# Memorandum

**Subject:** Variance Request for an Application to Construct a Septic System located at 4731 Knotty Pine Way, Mount Charleston, Nevada with the following provisions: 1) allow installation of a septic system on an undersized lot; 2) allow a reduced property line setback; and 3) allow a reduced building setback without a Cone of Influence letter submitted by a State of Nevada registered professional engineer.

Attachment D: Recorded Plat for Cathedral Rock View

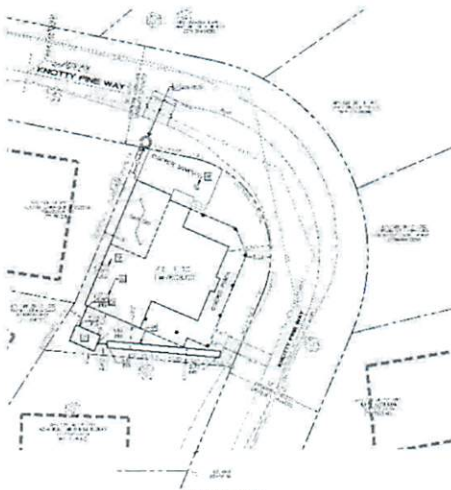
The Subject Property is depicted in Attachment D as Lot 16 of Block 5 of the recorded subdivision known as Cathedral Rock View, which was approved in 1956. The existing subdivision was created prior to the adoption of the current SNHD ISDS Regulations in 2006 and no recorded changes to the Subject Property have been recorded. There is one existing well located downgradient and within six hundred feet (600') of the proposed ISDS. The Subject Property is also located in an area with a high density of existing ISDS; there are 189 lots with an active, traceable ISDS permit within one square mile of the property boundaries (see attached ISDS Density Map).

### Attachment F: Absorption Trench Detail

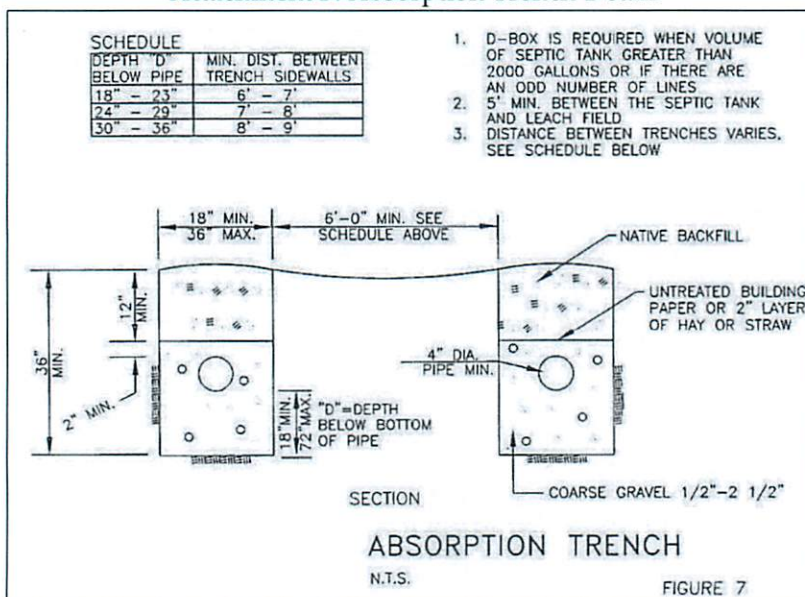
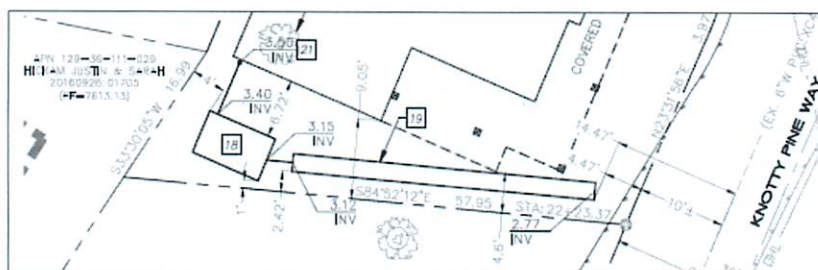
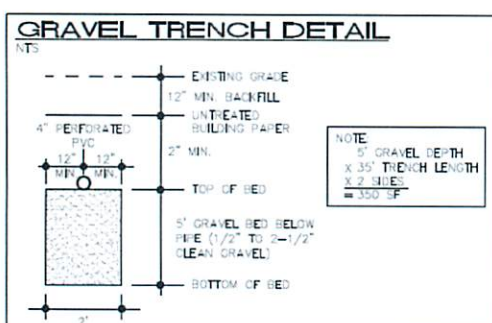
Under the SNHD ISDS Regulations, the side walls of absorption trenches are considered the primary infiltrative surface for design purposes (see Attachment F - Absorption Trench Detail). This contrasts with the design of absorption beds, for which the bottom of the bed is considered the primary infiltrative surface. Because of the way absorption trenches are designed, the extent of lateral wastewater movement from the trench is directly proportional to the trench depth, which is why the required separation between two trenches is equal to the combined depth of the two trenches (or for trenches of equal depth: [Separation Distance = Trench Depth x 2]). Therefore, if a seven foot (7') deep absorption trench is less than five feet (5') from the neighboring property line, the soil treatment zone will extend past the property line to the neighboring property.

Correction: Gravel depth will be 6.5' instead of 5' to be meet the required leaching area of 450 sqft.
